Delegated Report		Analysis sheet	Expiry Date:	23/06/2023
		N/A	Consultation Expiry Date:	09/07/2023
Officer		Application Number(s)		
David Peres Da Costa		i) 2023/1742/P ii) 2023/2290/L		
Application Address		Drawing Numbers		
12 Gloucester Gate, 12 & 13 Gloucester Gate Mews London NW1 4AD		Refer to draft decision notice		
PO 3/4	Area Team Signature	C&UD	Authorised Officer Signature	
Proposal(s)				
i) Erection of a double height glazed link connecting 12 Gloucester Gate and 12 and 13 Gloucester Gate Mews and associated works.				
ii) Erection of a double height glazed link connecting 12 Gloucester Gate and 12 and 13 Gloucester Gate Mews and associated works.				
Recommendation(s):		Non-determination: would have refused planning permission and listed building consent		
Application Type:		i) Full planning permission ii) Listed building consent

1. Proposal

Sectional diagram through curved link building setting out key tangents along the form

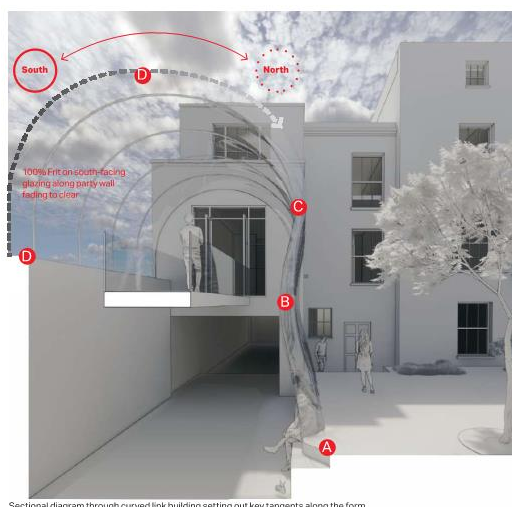
- 3.11. *The form of the link building is without any reasonable comparison or source anywhere on the terrace. Its waved form which curves over the window on the rear elevation of Gloucester Lodge is architecturally at odds with the orthogonal planning of the rest of the terrace.*

- 3.12. *The resulting clash of forms, and the protrusion of the building into the courtyard, is likely to lack context or subservience to the Grade I listed building. Historic England considers the result to be a harmful intervention to an otherwise highly significant historical composition.”*

- 3.13. Officers agree with this assessment and consider that the overall form and sectional profile of the proposed link will be jarring with the historic buildings. As such, the design will fail to be sympathetic to the sensitive historic context, namely due to the negative impact of the design on the principal host building and upon the curtilage mews building, as well as upon the neighbouring property to the south, and upon the wider conservation area context.

We think there are ways to reduce harm in line with paragraph 195 of the NPPF. We suggest options are explored to re-design the link building in a way that reinforces the spirit of the historic building rather than competing with it. In practice, we think the design would benefit from being lower in height and redesigned to be more complimentary to the listed building.

Figure 4: Gloucester Lodge as built by James Burton in 1827-28.

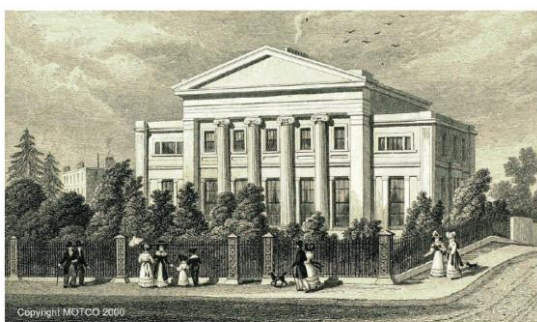
- 3.23. According to the submitted Heritage Statement, Gloucester Lodge was constructed as a detached dwelling to designs by James Burton in 1827-28 and was designed with a central pediment with four ionic columns supporting an entablature and two lower side wings. As an occupant could not be found, substantial alterations were undertaken in 1836 to create two semi-detached houses, the southern element becoming Gloucester Lodge (12 Gloucester Gate). The main entrance was relocated to a former window opening in the original south wing and a glazed vestibule added. Whereas 11 Gloucester Gate is the end of a larger terrace with four storeys, attic and basement, 12 Gloucester Gate is a semi-detached villa with three storeys and lower ground floor. The photograph below shows the significant difference in proportions between 12 Gloucester Gate (marked by a red arrow) and the neighbouring terrace to the south.

- 3.24. The plot width of the application site (north to south) is almost 14 metres, whereas the width of 11 Gloucester Gate is approximately 9 metres and 10 Gloucester Gate is only 7.6 metres (approx.). There are significant differences between the application site and the terrace to the south in terms of height, scale and size of courtyards, such that the five link structures to the rear of the terrace are of limited relevance and do not form a precedent for the current proposal.
